FRIENDS OF SAN LORENZO CREEK

Subject: Friends of San Lorenzo Creek Comments on PLN2020-00218

Application for a Conditional Use Permit to Fly Aircraft at 27172 Fairview Ave

ATTACHMENT A

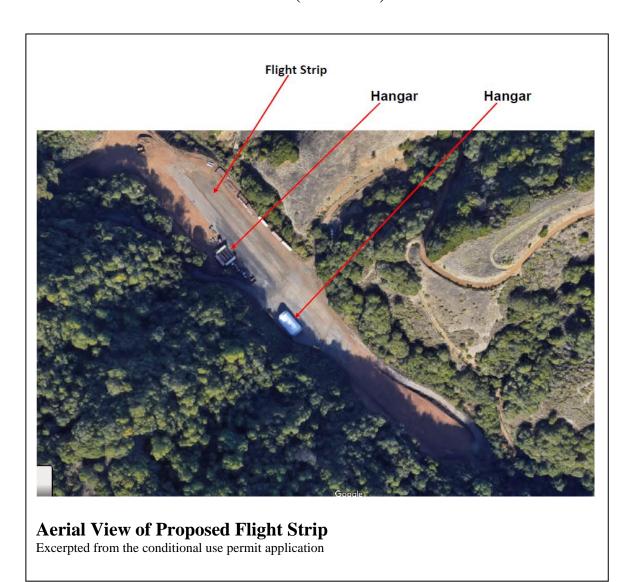
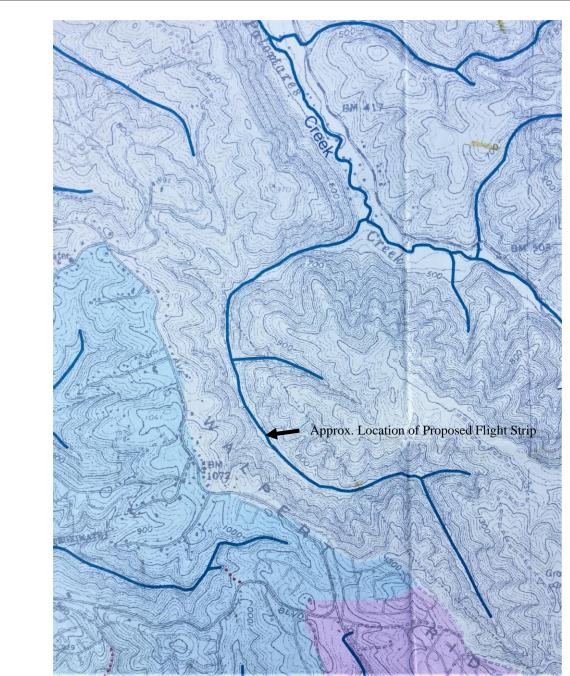
The proposed flight strip is on a creek on an agricultural zoned parcel that is covered by the urban growth limit requirements. See maps in Attachment A.

This parcel and proposed development are outside the urban growth limit (See map in Attachment A). Proposed uses and development must comply with the Measure D urban growth requirements such as Floor Area Ratio (FAR) requirements. Assess compliance with Measure D.

ATTACHMENT C Threatened Species Habitat Locations

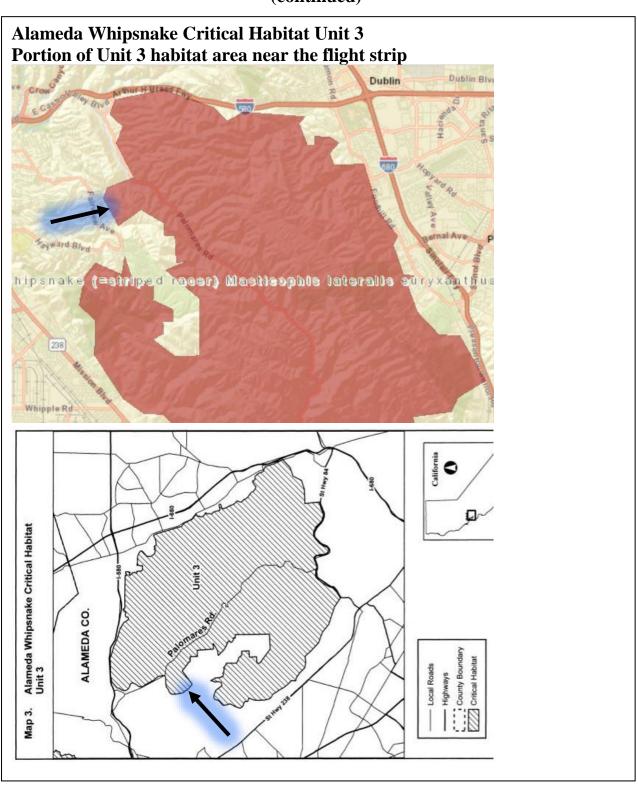
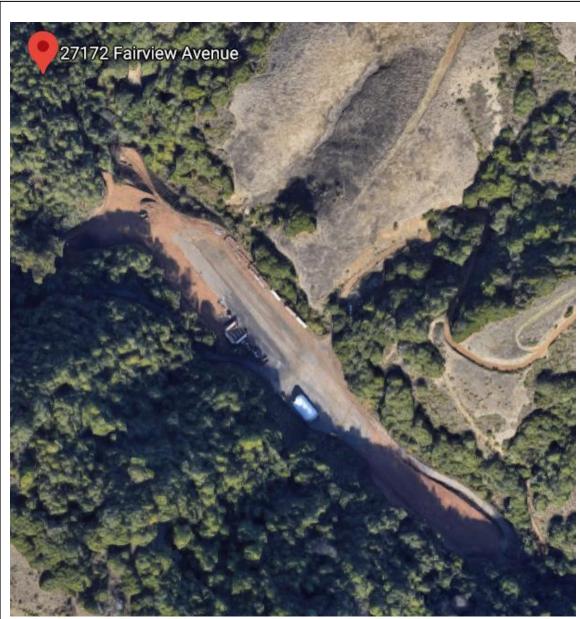
- Define the location, length, and extent of the creek culvert and earthen fill that was approved under a 1989 CDFW Lake and Streambed Alteration Agreement
- Define the location and presence of the 20 native species trees (black walnut, oak, bay, etc.) that the 1989 CDFW agreement required to be planted along the relocated flow line of the creek.
- Define the location of natural creek that was not culverted under the 1989 CDFW agreement, along with the location of natural creek that exists today. These locations also need to include the locations of the creek toe and minimum creek setback (see Attachment B)
- Assess, describe, and locate habitat and wildlife, including:
 - o Native trees, woodland, and vegetation
 - o Potential Red-legged frog and Alameda whipsnake habitat (see CDFW critical habitat in Attachment C)

ATTACHMENT D Historical Aerial Views of Flight Strip Area Showing Example of Newer Grading & Filling

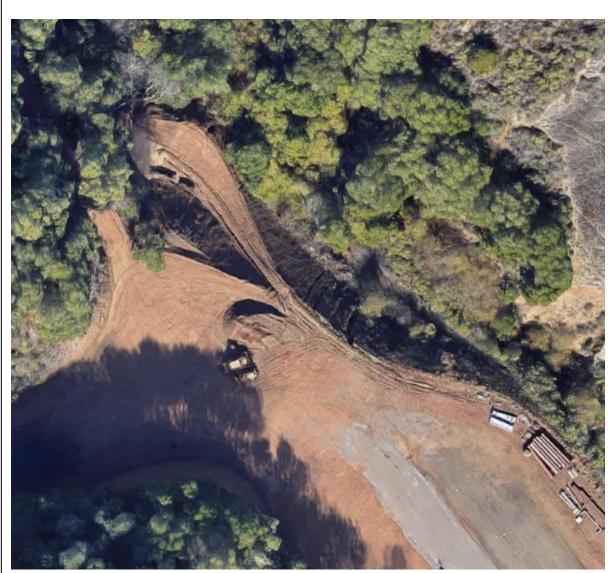
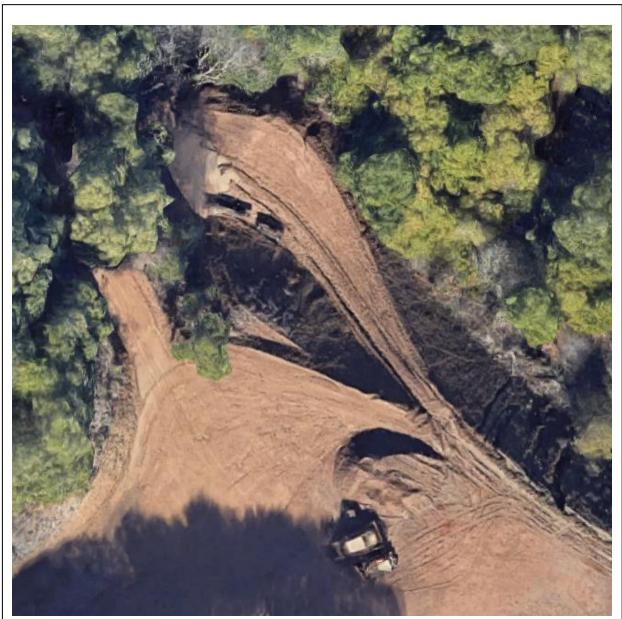
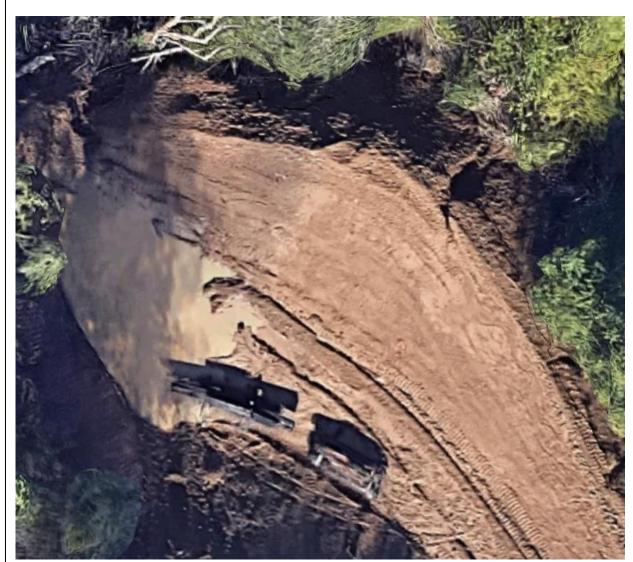
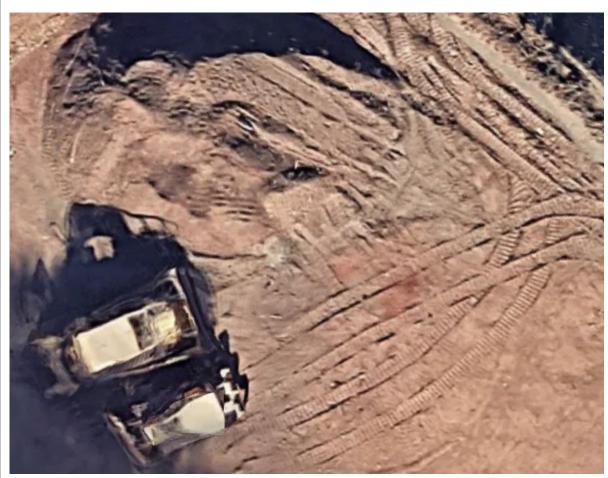
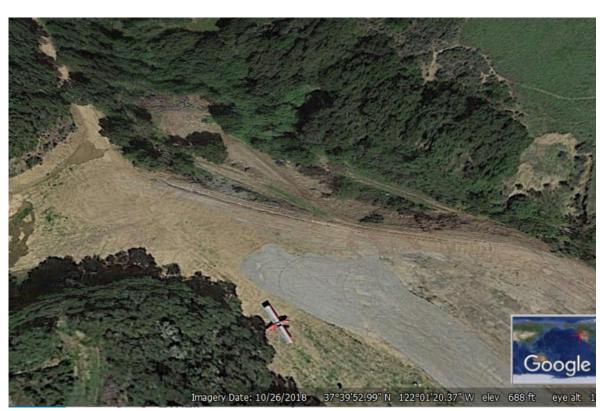
- Define the location and extent of other (possibly unpermitted) grading and fills at and supporting the proposed flight strip site. Examples include:
 - O 2020. Grading and fill shown on 2020 Goggle Earth images (see Attachment D) as extensive, newer, unpermitted earth moving at the north end of the flight strip. Images appear to show several pieces of heavy equipment such as a bulldozer that were pushing dirt over the edge into large areas of trees and possibly the creek in the lower valley. The location of the creek in this valley area is not apparent on the satellite images.
 - 2000-2005. Grading and fill shown on 2000 versus 2005 Goggle Earth images (see Attachment D) as filling in the uphill drainage area at the north-west end of the flight strip to create more flat area and possibly a new section of road to access the flight strip.

- c) Remove developments and restore creek setback areas. Remove and/or stop WPO-defined "developments" in setback areas, including structures and activities such as: structures, hangers, storage containers, land grading and fills, roads, parking areas, fences, piling debris, and activities that move/disturb natural materials such soils and vegetation. Restore compacted soils and replant with locally endemic, native vegetation in any setback areas that were damaged.
